Planning Application No. A/YL-KTN/1176

Table A: Responses to Departmental Comments

Project 項目名稱:
Proposed Temporary Private Club for a Period of 3 Years at
Lot 130 RP in D.D.110 and Adjoining Government Land ,
Kam Tin, Yuen Long

Drawing Title 圖紙標題:
Swept Path (Out)
Drawing No. 圖號:
20240302

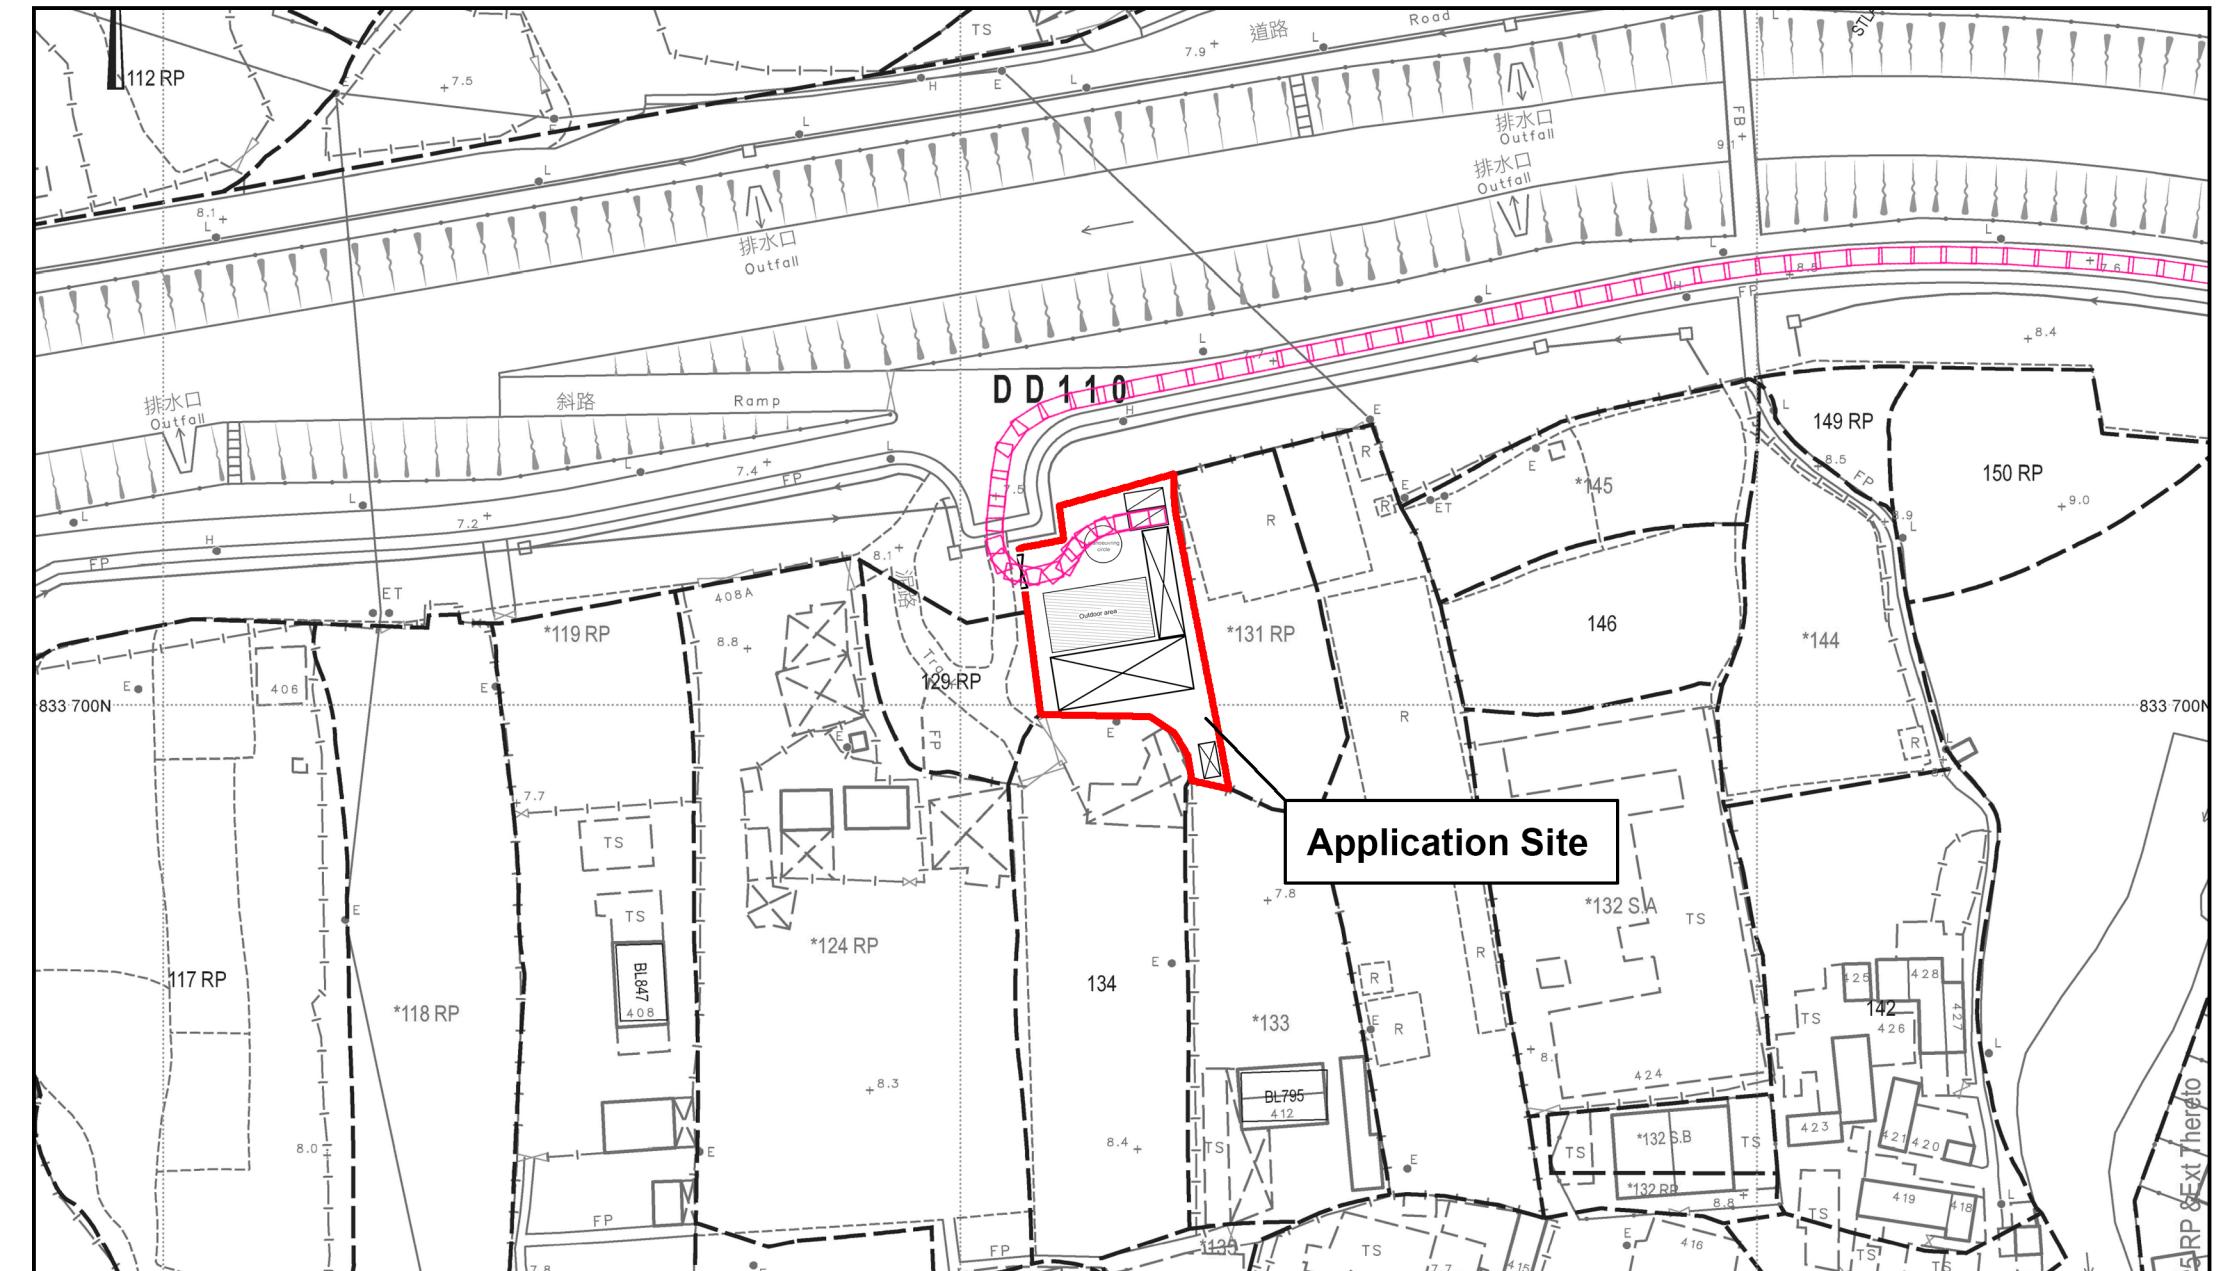
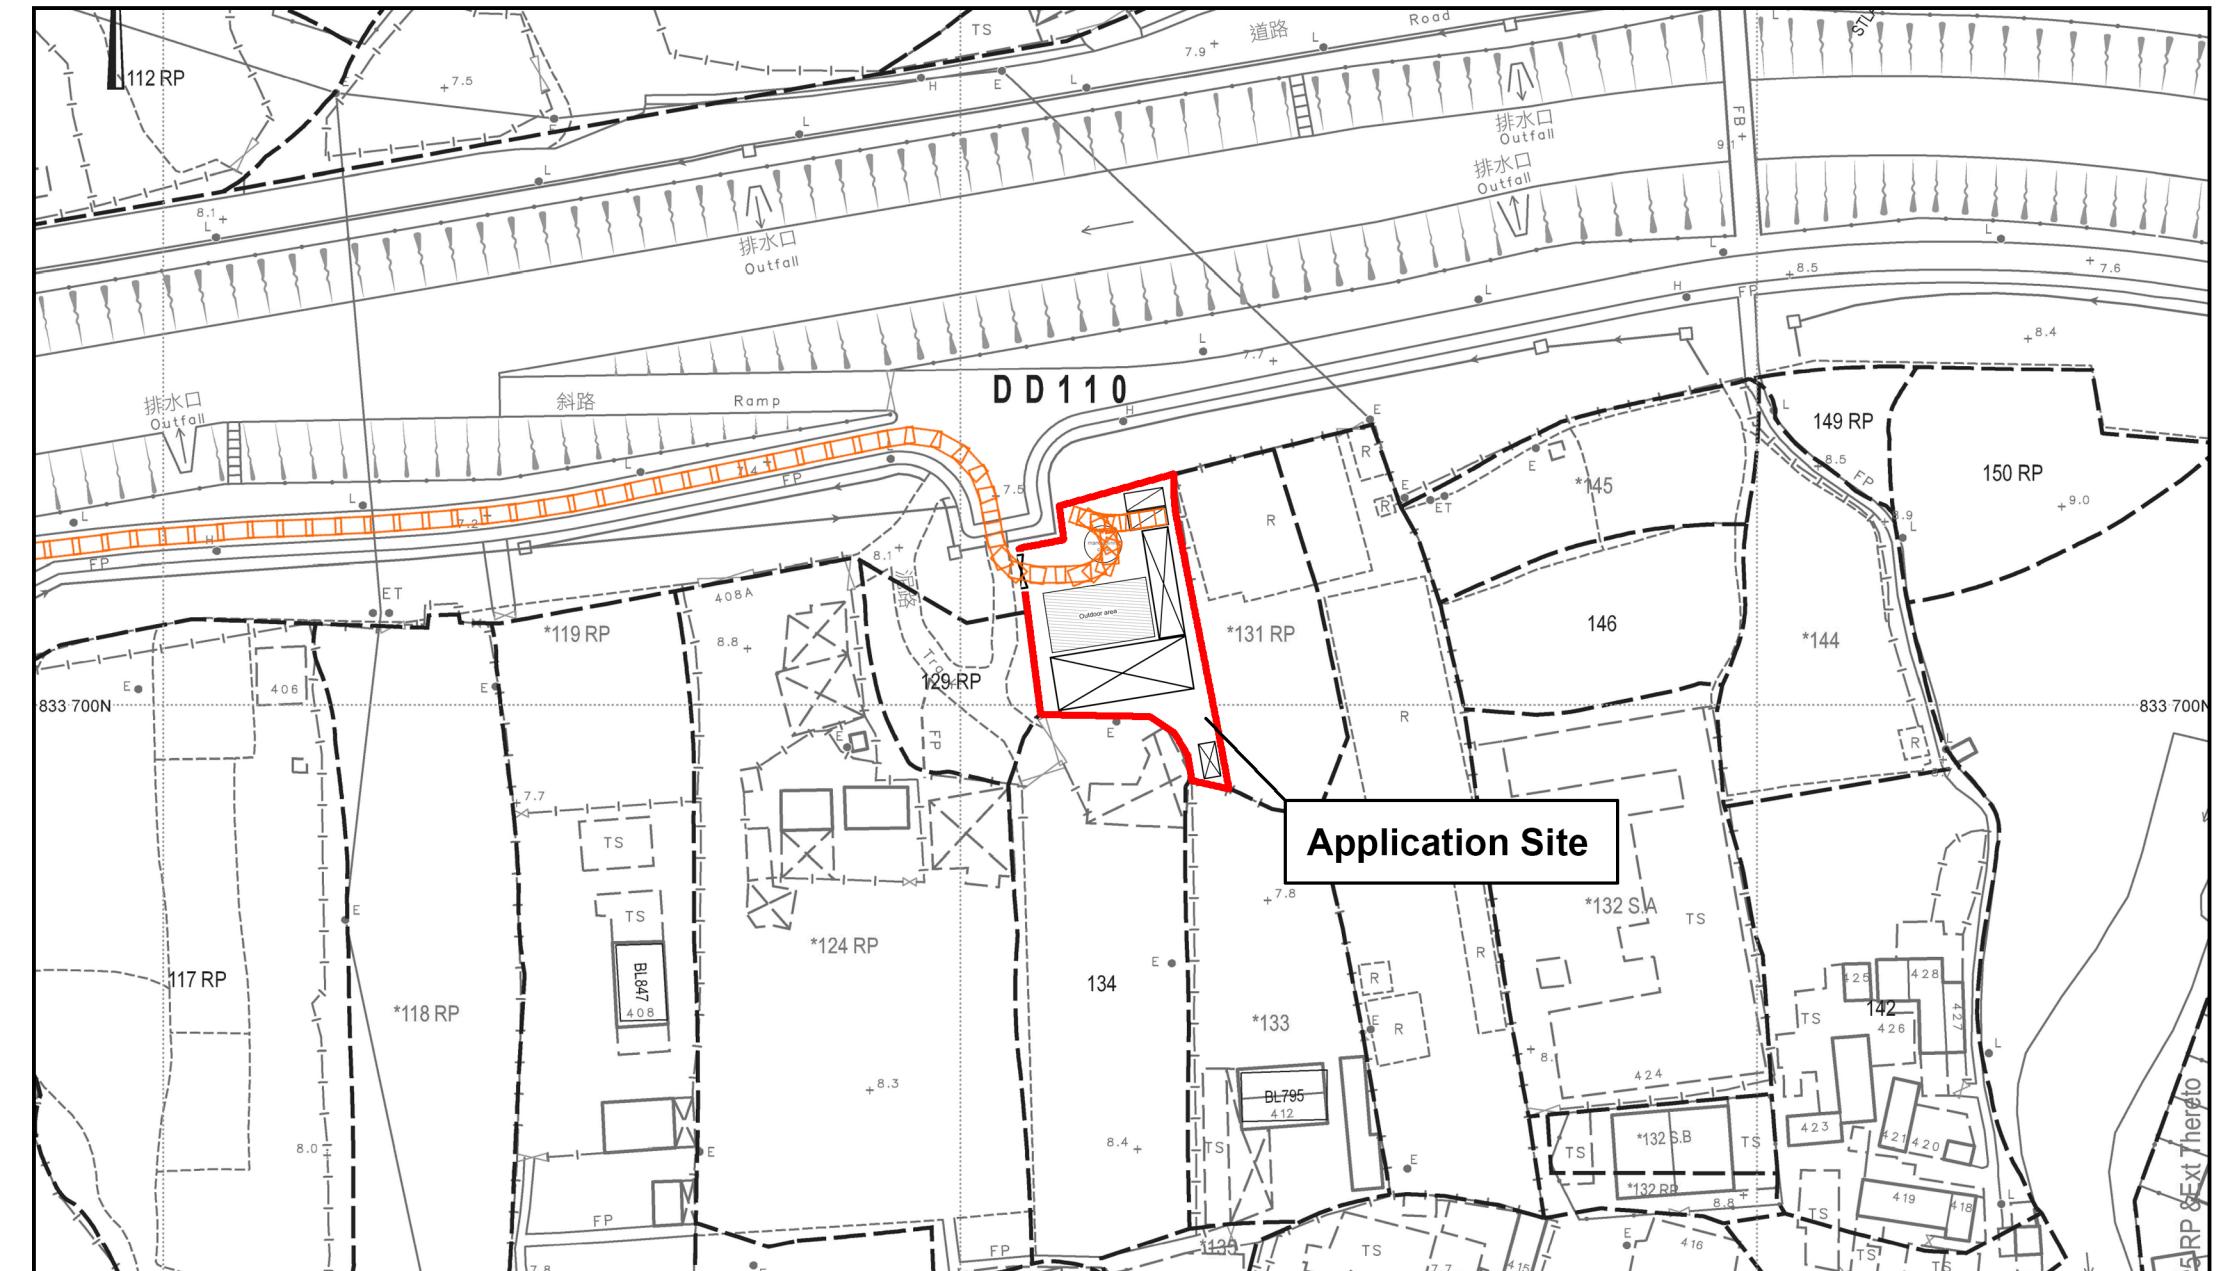
Departmental Comments	Responses
Transport Department (Contact: Mr Phil CAI at 2399 2421)		
(1)	<p>The applicant should demonstrate the smooth manoeuvring of vehicles to / from Kam Ti Road, along the local access and within the site; and</p> <p>The applicant should note the local access between Kam Ti Road and the site is not managed by this Department.</p>	<p>申請人知悉。 請看附件的Swept Path Analysis.</p>

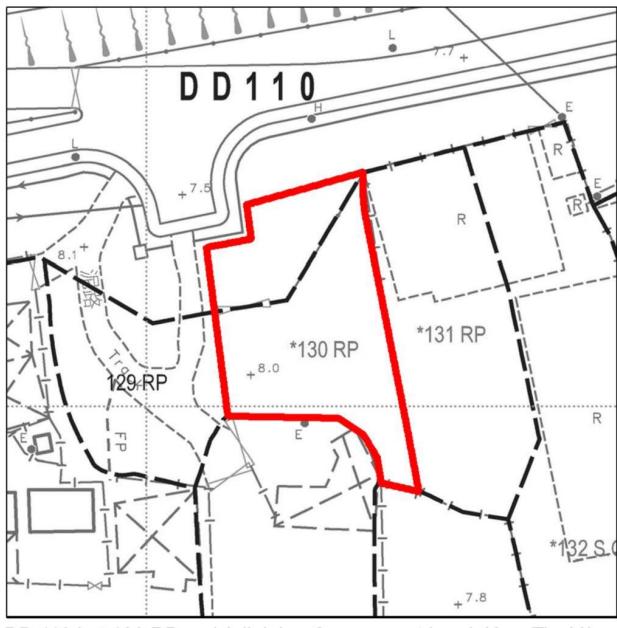
Departmental Comments	Responses
Highway Department		
1	<p>The applicant shall provide a proposal on the vehicular access arrangement including the run-in / out design for the vehicles leaving / entering the proposed use;</p>	<p>有關申請地點錦泰路的車輛進出口通道建議， 請看下圖，現場已設置車輛出入口通道。</p>

Proposed FS Plan

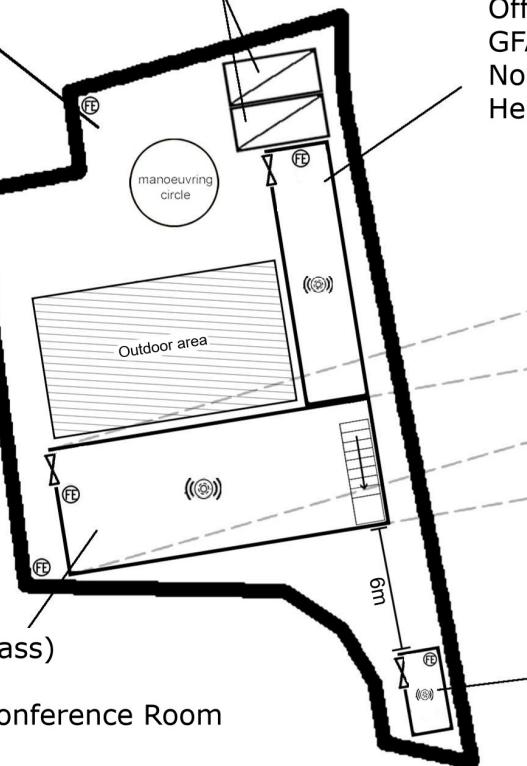
Departmental Comments	Responses
	Comments from Fire Services Department	
(1)	<p>With regard to the submitted FSI proposal, I have the following comment:</p> <p>For enclosed structure with gross floor area not exceeding 230m², only fire extinguisher and Stand-alone Fire Detector shall be provided;</p> <p>In relation to (1.) above, where two or more Stand-alone Fire Detectors are installed in an enclosed structure, all stand-alone detectors shall be interconnected (either wired or wirelessly) such that when one of the stand-alone fire detector is triggered, all connected Stand-alone Fire Detectors shall sound an alarm simultaneously;</p> <p>The Stand-alone Fire Detector shall be provided in accordance with the “Stand-alone Fire Detector General Guidelines on Purchase, Installation & Maintenance [Sep 2021]”; and</p> <p>Emergency lighting, directional and exit signs are considered as self-upgrade and not a mandatory requirement by this Department.</p> <p>However, the applicant is reminded that if the proposed structure(s) is required to comply with the Buildings Ordinance (Cap. 123), detailed fire services requirements will be formulated upon receipt of formal submission of general building plans.</p>	<p>申請人已修正消防圖。</p> <p>請看附件的 FS Plan。</p>
